BULLETIN

No. H01A-002

SUBJECT: EXPAND-IT ATTACHMENTS DO NOT FIT NEW MODEL TRIMMERS

AFFECTS: YARD SMART UNITS AND VERSA TASK ATTACHMENTS

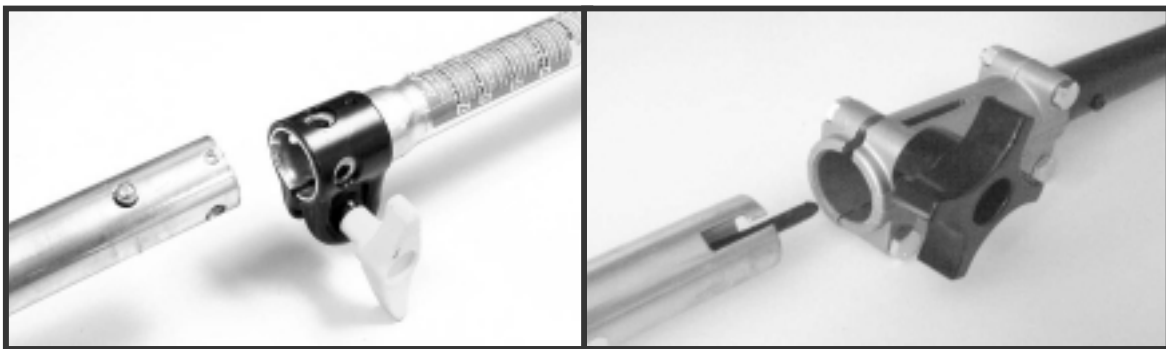
Expand-It attachments do not fit the new trimmers, couplers are different on the new model string trimmers.

This new Quik-Tatch coupler (A) used on the new Yard Smart Series of trimmers is different than the Expand-It coupler (B) used on all prior attachment capable Homelite® models. Because of this the new Versa Task Attachments using the Quik-Tatch coupler are not interchangeable with Expand-It attachments.

Order the correct part number attachment for the proper unit.

Versa Tool Attachments for current units.		Expand-It Attachments for all units built prior to 2000.	
(Yellow Knob Coupler)		(Black Knob Coupler)	
Blower	UT15500	Blower (BA250)	UT15511
Edger	UT15502	Edger (EA250)	UT15513
Cultivator	UT15501	Cultivator (CA250)	UT15514
Brushcutter	UT15503	Brushcutter (BCA250)	UT15512
